CH2M HILL ENGINEERING CHANGE NOTICE

1a. ECN 721866 R 0

8. Title S-102 Initial Retrieval Functions and Requirements		9. Bldg. / Facility No. S-Farm	10. Equipment / Component ID NA		11. Approval Designator EQ

12. Engineering Documents/Drawings to be Changed (Incl. Sheet & Rev. Nos.) RPP-10901, Rev. 1B			13. Safety Designation <input type="checkbox"/> SC <input type="checkbox"/> SS <input type="checkbox"/> GS <input checked="" type="checkbox"/> N/A		14. Expedited/Off-Shift ECN? <input type="checkbox"/> Yes <input checked="" type="checkbox"/> No
15a. Work Package Number NA	15b. Modification Work Completed NA <small>Responsible Engineer / Date</small>		15c. Restored to Original Status (TM) NA <small>Responsible Engineer / Date</small>		16. Fabrication Support ECN? <input type="checkbox"/> Yes <input checked="" type="checkbox"/> No

Figure 5.3. Proposed Tank S-102 Saltcake Waste Retrieval System

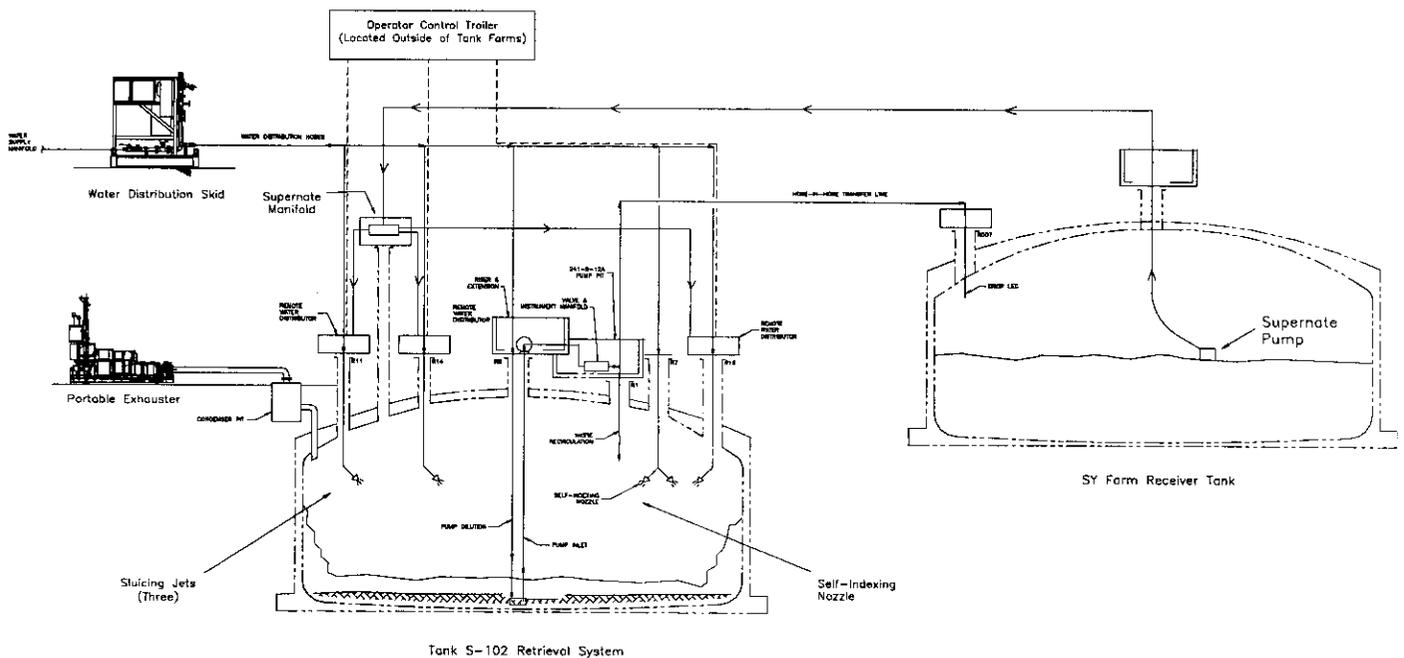
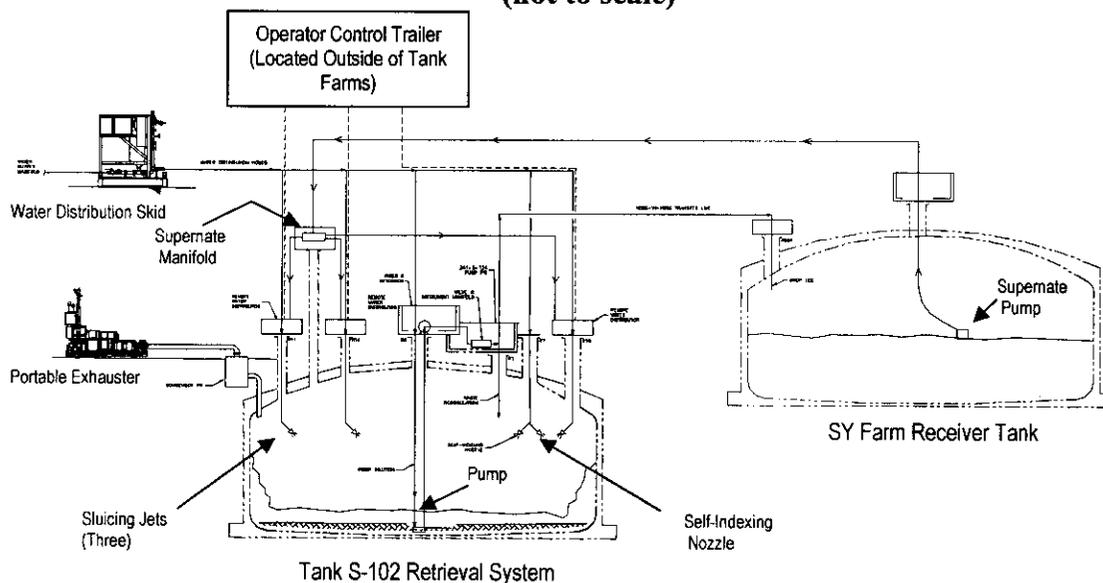
- **Supernate distribution system:** Supernate from the SY Farm DSTs shall also be used to mobilize and dissolve S-102 waste. The components needed to recirculate supernate are generally illustrated in Figure 5.3, and general requirements are given in Section 4.8.

Change to Figure 5-3, Page 5-12:
